3rd Further Information

Temporary Wholesale Trade with Ancillary Storage for a Period of 3 Years in "Residential (Group D)" Zone, Lot 2339 (Part) in D.D. 130, Lam Tei, Tuen Mun, New Territories

(S.16 Planning Application No. A/TM-LTYY/484)

Responses-to-Comments

FS-01

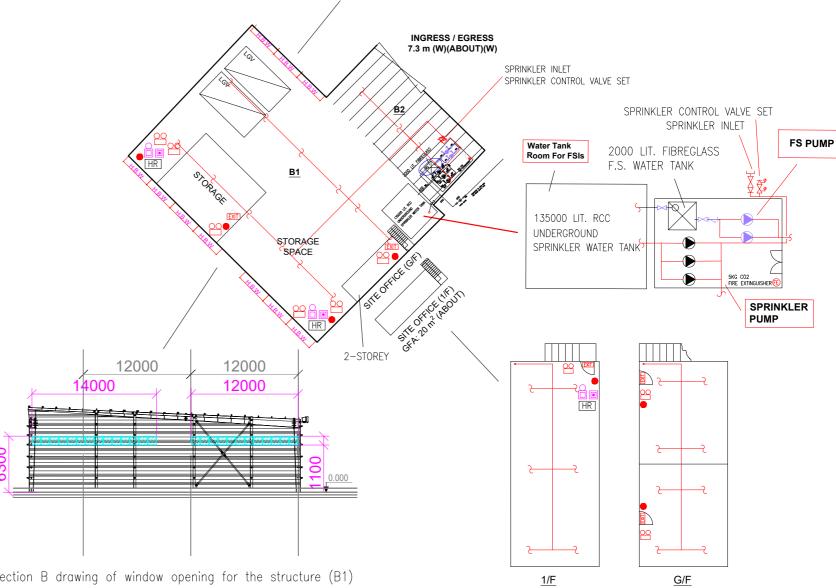
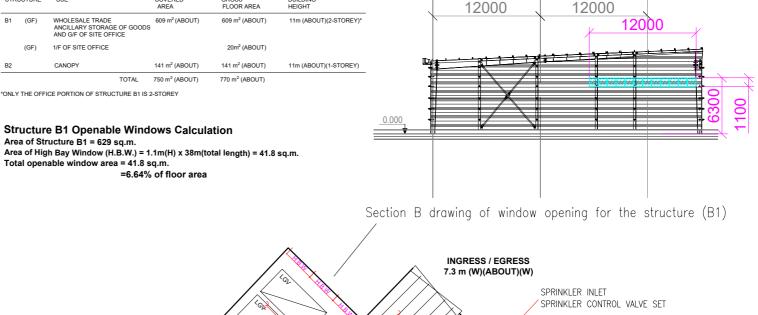
Departmental Comments		Applicant's Responses
1. Comments from the Director of Fire Services (D of FS)		
Contact Person: Mr. CHEUNG Wing-hei (Tel.: 2739 8775)		
(a)	The height of openable windows in the Section B drawing is not tally with the calculation.	5 , . ,
